**FORMAT B.1****Format for Technical Pre-Bid Queries****Tender No** TPSODL/OT/2021-22/042**Package Name** Rate Contract for Supply of FRP V Cross Arm**Bidder :**

### FRP CROSS ARM FOR LT (1.1kV)

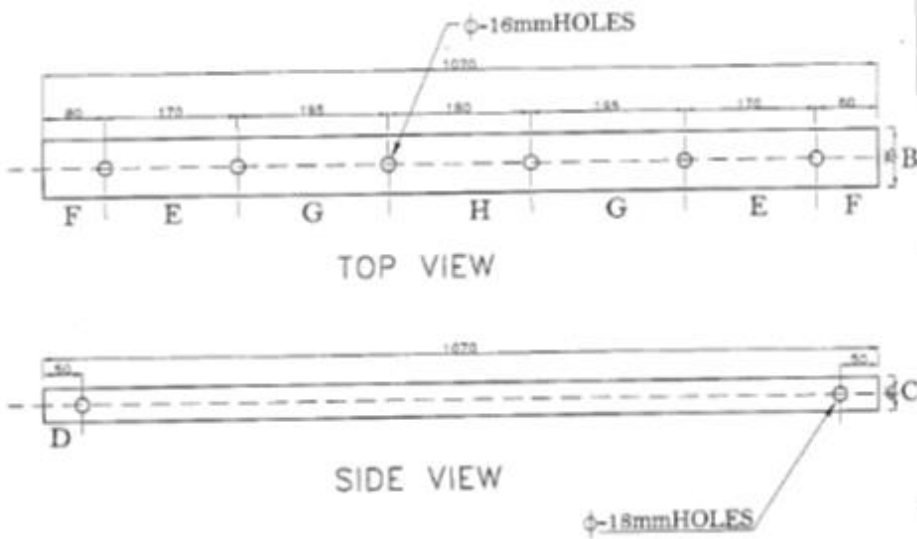
3	Clause No.4 (Technical specifications)Point No.17, Page No.28	Glass Content 65%	Generally FRP V Cross Arm made out of with Glass Content 25% to 30% Max. It may be accepted as can't be made of 65% & no need, so please amend the same in TS and required Type Tests also.	Specification to be complied
4	Drawing Page No.36	The holes distance (c-c) for clamp, as per drawing it should be 275 mm	We can provide holes distance (c-c) 230mm as it is generalized by other customers for the same & may be accepted also it is suitable for pole mounting.	Our requirement is only FRP Cross arm for installation of distribution boxes at pole, not V Cross Arm (Drawing Enclosed)
5	Drawing page No.35,36		As per your tender drawing, you have asked for separate support bar (as per page no. 35 & 36 drawing) where we suggest that you please amend the same with single moulded piece of FRP V Cross Arm. Should be in single moulded piece with support bar (also we can provide the drawing for the same if asked)	Our requirement is only FRP Cross arm for installation of distribution boxes at pole, not V Cross Arm (Drawing Enclosed)

6	Drawing page No.35,36		You have not asked for the Top hamper. Any where in specs & drawing same may also be incorporated	Our requirement is only FRP Cross arm for installation of distribution boxes at pole, not V Cross Arm (Drawing Enclosed)
7	Drawing page No.35,36, Annexure-I (Schedule for items)		In tender docs the two different items drawing given, However BOQ is given for single item. Please clarify the required item.	Our requirement is only FRP Cross arm for installation of distribution boxes at pole, not V Cross Arm (Drawing Enclosed)
8	In reference to clause 19.0- Sr. No. 17	Glass Content Requirement is 65%	We request you to amend Glass Content Requirement as Min. 55%, please mention Manufacturing Process herewith because it is not achievable in SMC	Specification to be complied
9	clause 13.0	In reference to clause 13.0 for sample Submission, which states to supply One No. of sample of 'FRP Cross Arm' at the time of offer submission in tender at Plant Engineering Department.	Please allow us to submit at the time of Technical Evaluation/after LOA	Specification to be complied
